UNITED STATES PATENT AND TRADEMARK OFFICE

10/566,053

Peter Geskes

Office Action Summary	Application No. 10/566,053	Applicant(s) GESKES ET AL.	
	Examiner Allen J. Flanigan	Art Unit 3744

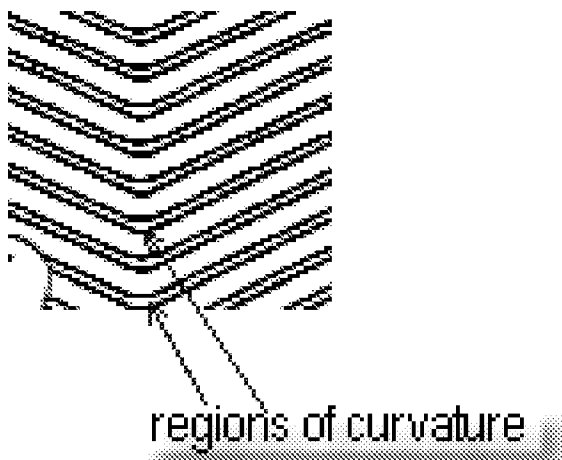
Claims 1-4, 11, 12, 17-21, 23, 26, and 28-36 are rejected under 35 U.S.C. 102(b) as being anticipated by Karlsson et al.

Karlsson et al. show a plate heat exchanger in which the plates are provided with a “pressed pattern (9)” (note in regard to the embossing step of claim 30) of corrugated profiles comprising rectilinear portions joined by curved portions (see Fig. 12, for example) that read on the claimed “regions of curvature”.

Adjacent plates are reversed to provide points of contact (see Fig. 8) which inherently define meandering flow patterns. The plates are brazed

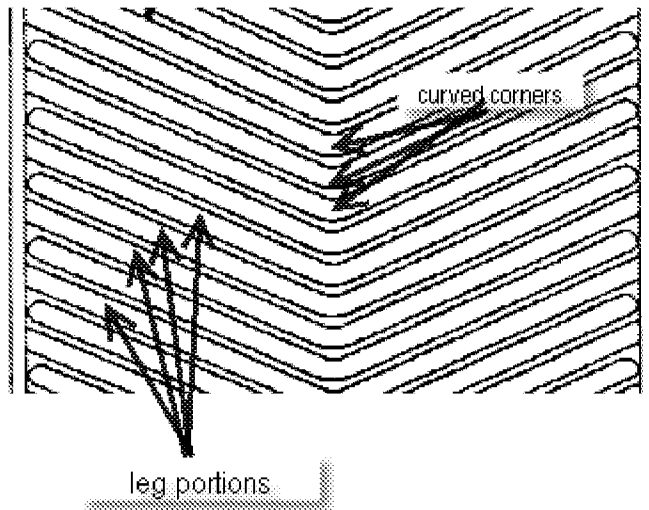
together at their points of contact. Regarding the recitation that the plates “have a recurring wavy profile” in claim 1, see Figs. 14 or 17 of Karlsson et al., showing the wavy profile of the plate when viewed in cross section. Regarding claim 2, the corrugated profile will indeed appear wavy when viewed transverse to the flow direction between the inlet and outlet openings (i.e. when viewed along a transverse cross section of the plate parallel to line XVI).
